From: Albert Torrico <al@sagehomesnw.com>
Sent: Thursday, May 26, 2022 10:59 AM
To: Niels Tygesen <NTygesen@everettwa.gov>
Cc: Steve Ingalsbe <SIngalsbe@everettwa.gov>
Subject: [EXTERNAL] Harbor's Edge HE Decision
Importance: High

I left you a VM regarding the HE decision, but there seems to be some errors in the findings of fact that translated into conditions that aren't accurate. See my summary below.

3 Floors

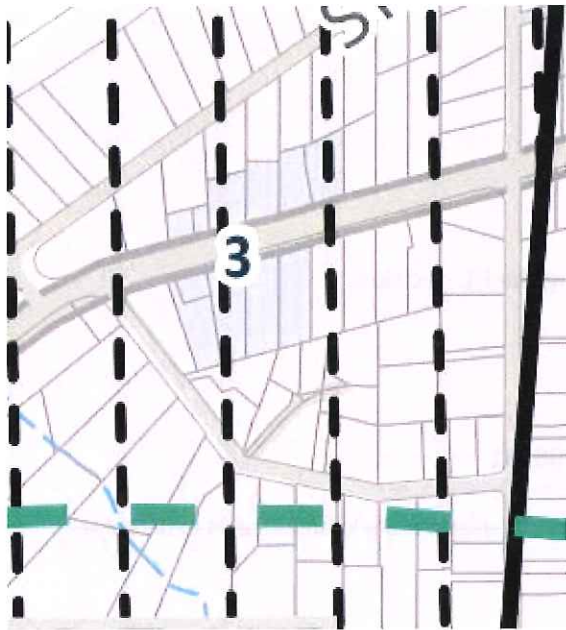
#15 I don't believe this is correct. The maximum height in the NB zone is 3 three floors, except along the east and south property lines building height is limited to 28' within 35' of those property lines. All the buildings are more than 35' from the east and south property lines and can be a maximum three floors. The HE discussion is inconsistent with the staff report and I believe reviewing the building structures height map, referenced by the Hearing Examiner, that the four parcels comprising our site are darker and indicate a height of three stories, which is consistent with the NB zoning of the parcels.
